SUBJECT: NOTICE OF DETERMINATION OF FINAL EIS  
CENTAL MAUI SANITARY LANDFILL PROJECT

FINAL ENVIRONMENTAL IMPACT STATEMENT  
**CENTRAL MAUI SANITARY LANDFILL PROJECT**

FINAL  
ENVIRONMENTAL IMPACT STATEMENT  
FOR THE  
CENTRAL MAUI SANITARY LANDFILL PROJECT

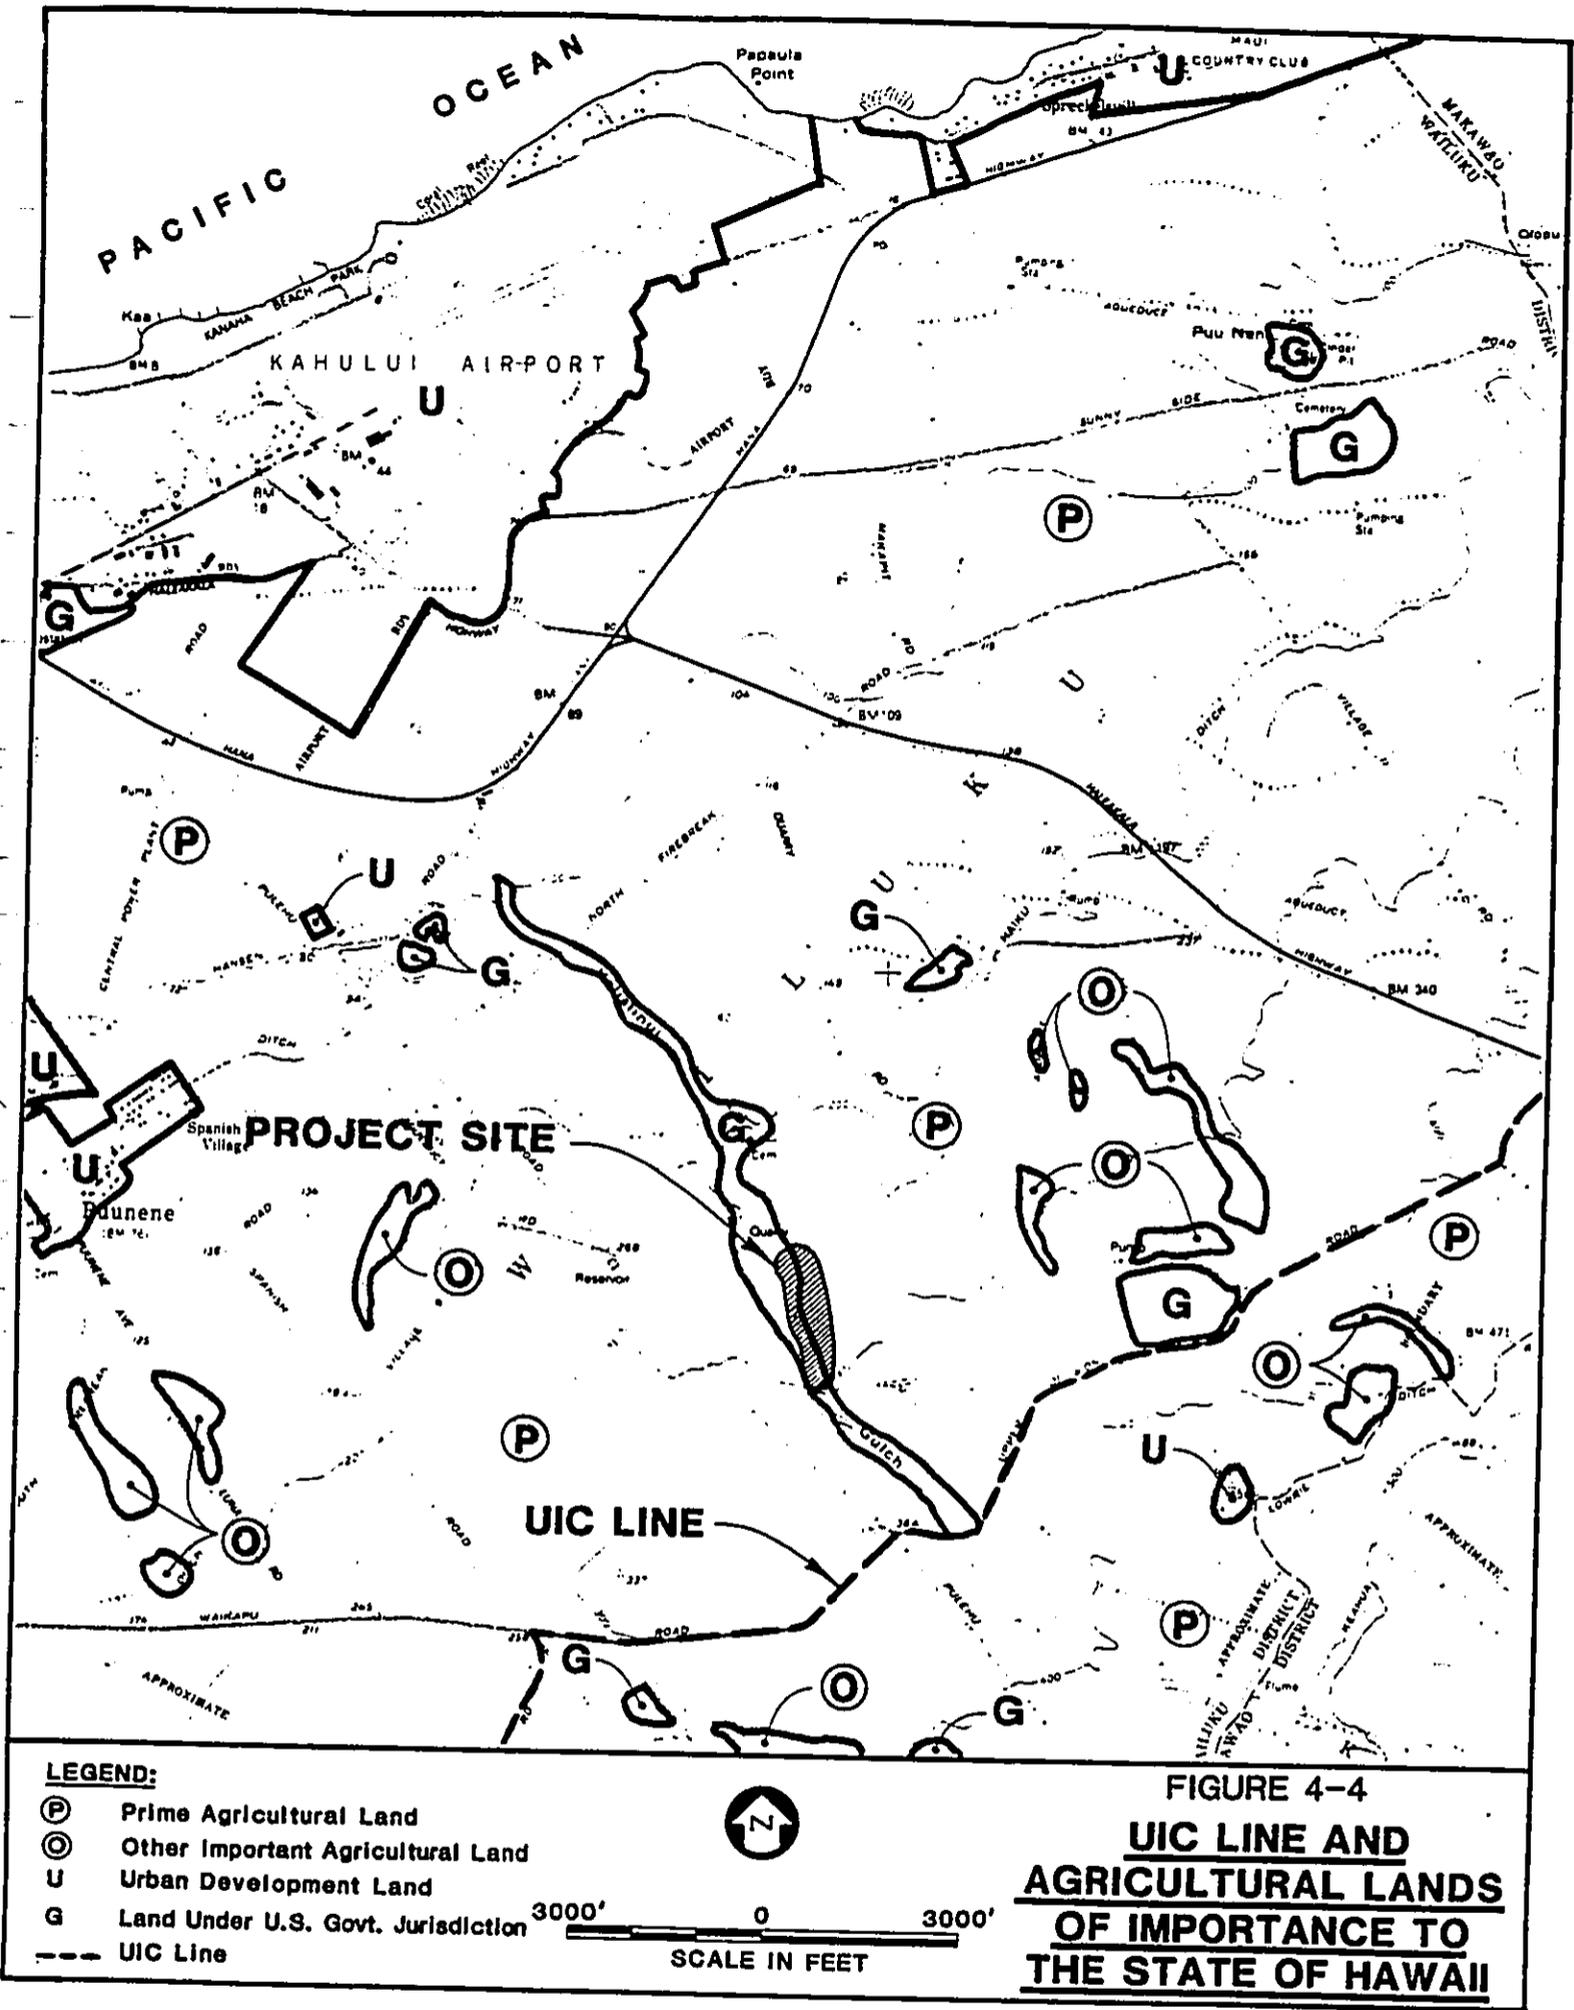
In response to your question concerning the UIC line, that portion of the line that passes near the vicinity of the project site is shown in Figure 4-4 of the Draft EIS. A discussion of the State Underground Injection Control Program is given in Section 4.3.3 on page 4-7.
